**DOCKET 50-255 - LICENSE DPR-20 - PALISADES NUCLEAR PLANT
RISK-INFORMED INSERVICE INSPECTION PROGRAM – RESPONSE TO
REQUEST FOR ADDITIONAL INFORMATION (TAC NO. MB4420)**

**RISK-INFORMED INSERVICE INSPECTION PROGRAM
RESPONSE TO REQUEST FOR ADDITIONAL INFORMATION**

RISK-INFORMED INSERVICE INSPECTION (RI-ISI) PROGRAM

PALISADES PLANT

Figure 1a: Diagnosis Dependency Decision Tree

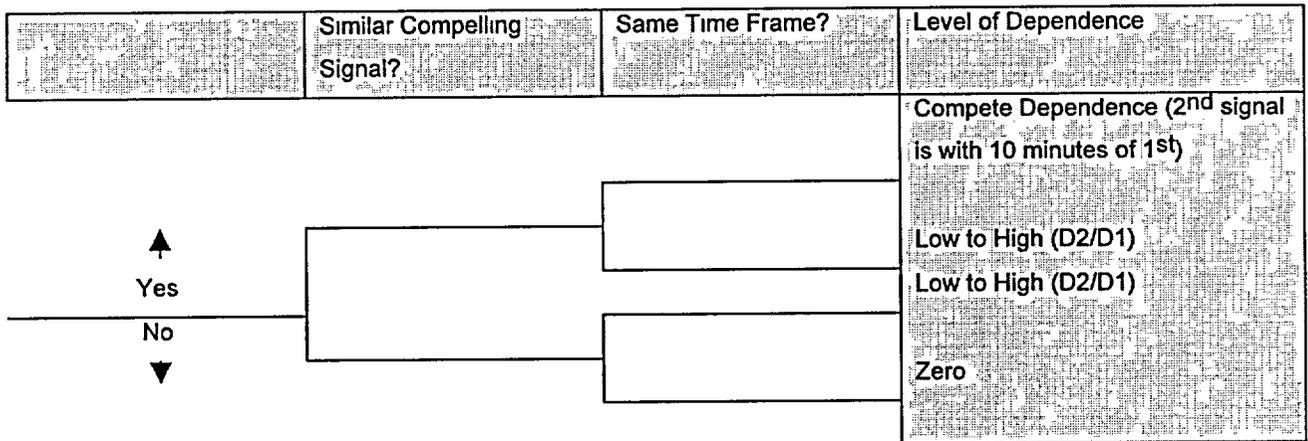
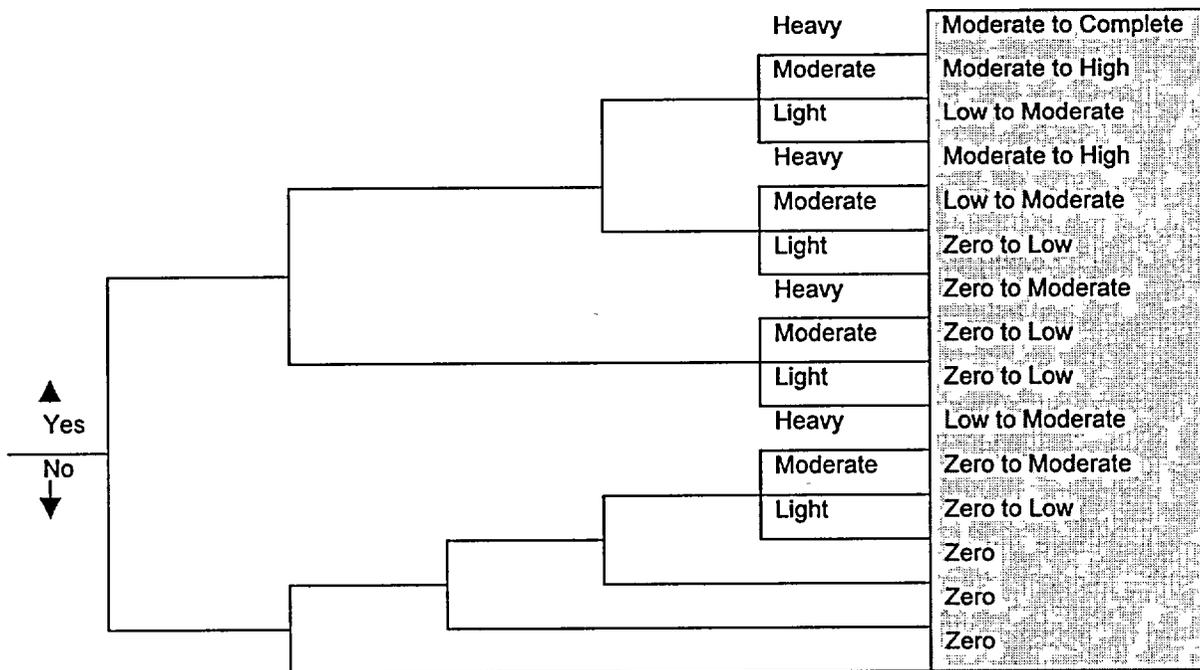
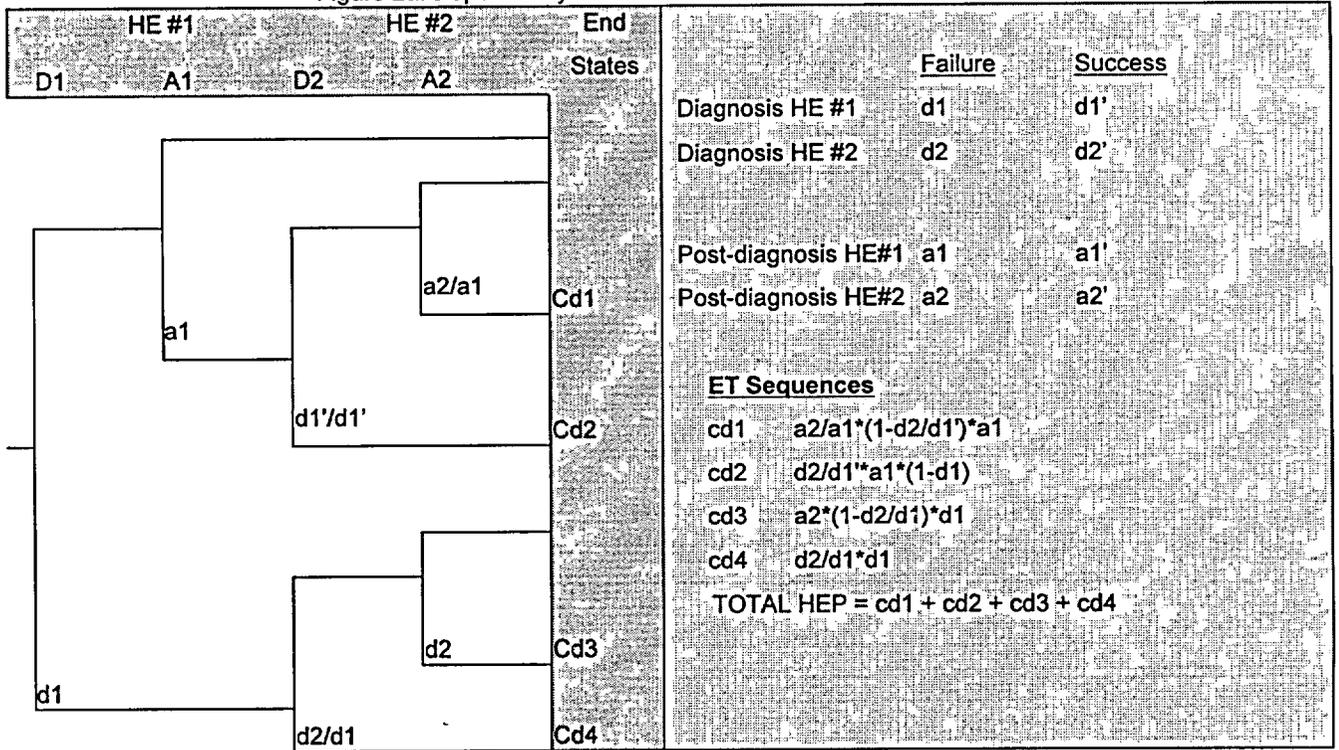
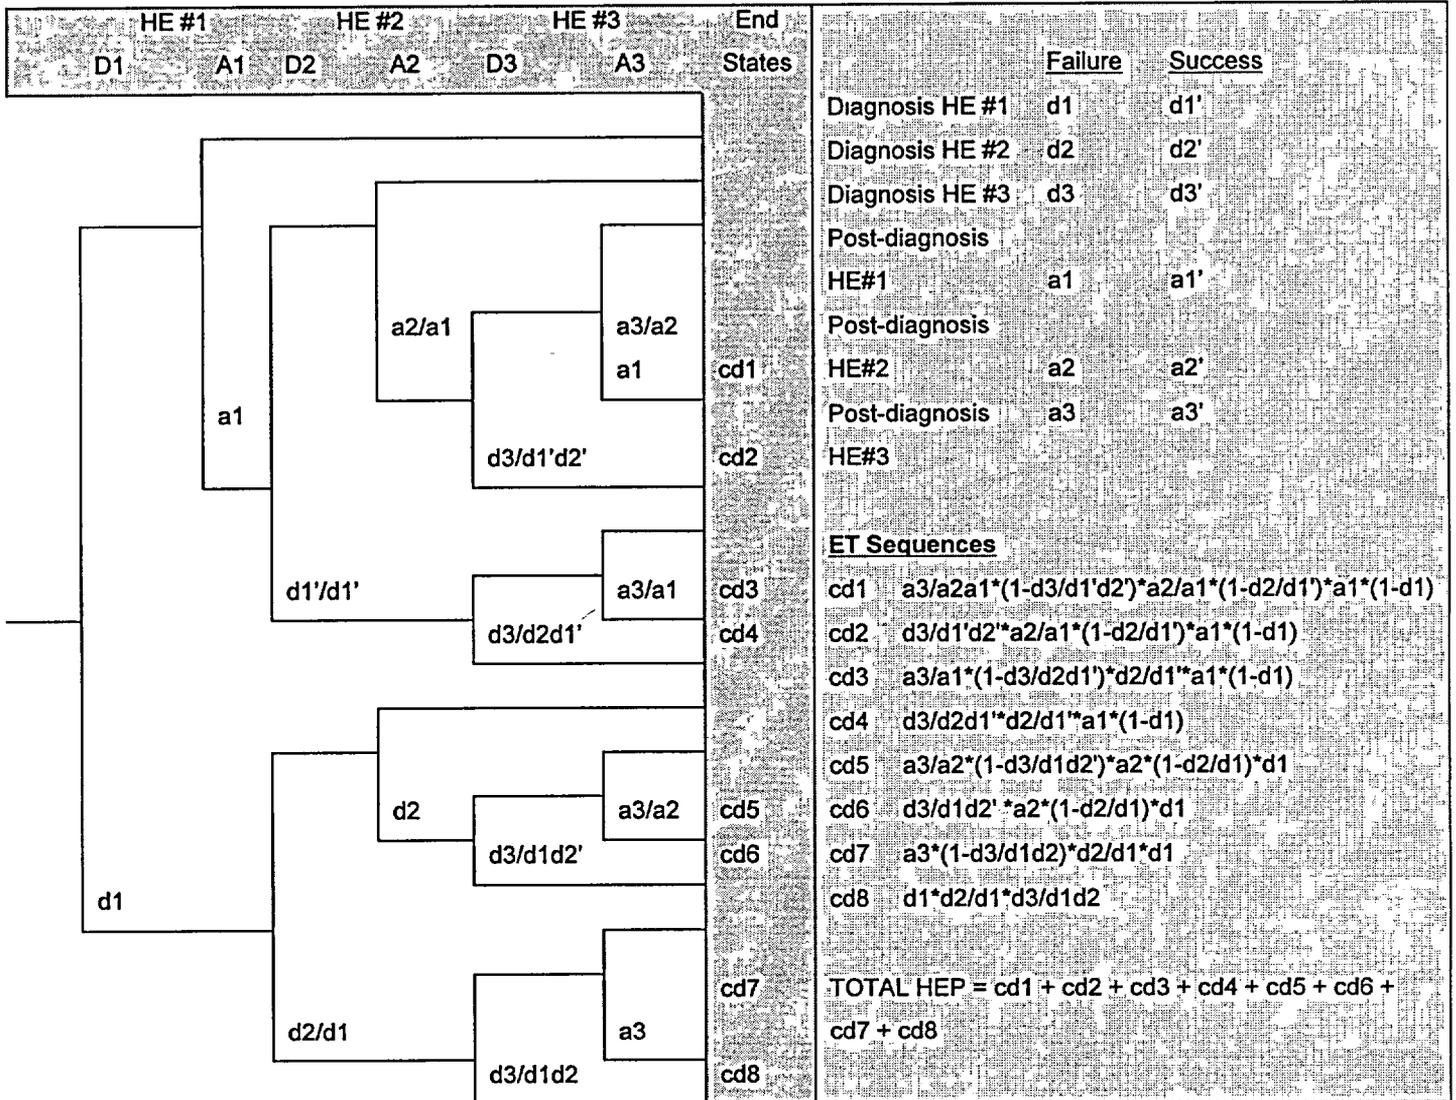
3. *In the enclosure to your letter dated March 1, 2002, Section 1.2, "PSA Quality," states that the Combustion Engineering Owners Group (CEOG) peer review performed in May 2000 found a weakness in performing a thorough dependency analysis for the operator actions modeled in the PSA. You state that the "weakness related to the appropriateness of the magnitude of human error probabilities used in the model given the possibility that dependent operator actions may not have been adequately considered." In general, omitting the dependencies between multiple operator actions yields lower human error rates for a sequence of actions. Your reported investigation that observed a slight increase in risk after including the dependencies in a number of multiple actions is consistent with this general observation. However, on page 2, you continued that you chose not to "remove further some of the conservatism by assessing more human error combinations...[because]...additional evaluation is not considered necessary due to the already small increase in [core damage frequency] CDF."*

Including dependencies between human actions does not "remove conservatism" -- it removes non-conservatism. The small increase in CDF observed from the completed evaluation does not alone support the conclusion that further evaluation would not yield larger increases.

Please explain how the incomplete review of dependencies could affect the evaluations performed in support of this relief request.

The method consisted of the steps outlined below. The ASEP [1] and THERP [2] (THERP was used to identify the conditional dependencies in this evaluation, only) human error methodologies to assess and quantify dependent human error probabilities (DHEP) between the errors as shown in Figures 1a and 1b were employed. The human error dependency analysis consisted of the following steps.

3. Identify all post-initiating event operator error event combinations in the same CDF cutset in the baseline CDF equation.
4. Identify the combinations that are considered independent using the decision trees presented in Figures 1a and 1b.

6. Select several human error combinations that are not independent in accordance with Figures 1a and 1b and derive conditional values based on Figures 2a and 2b.
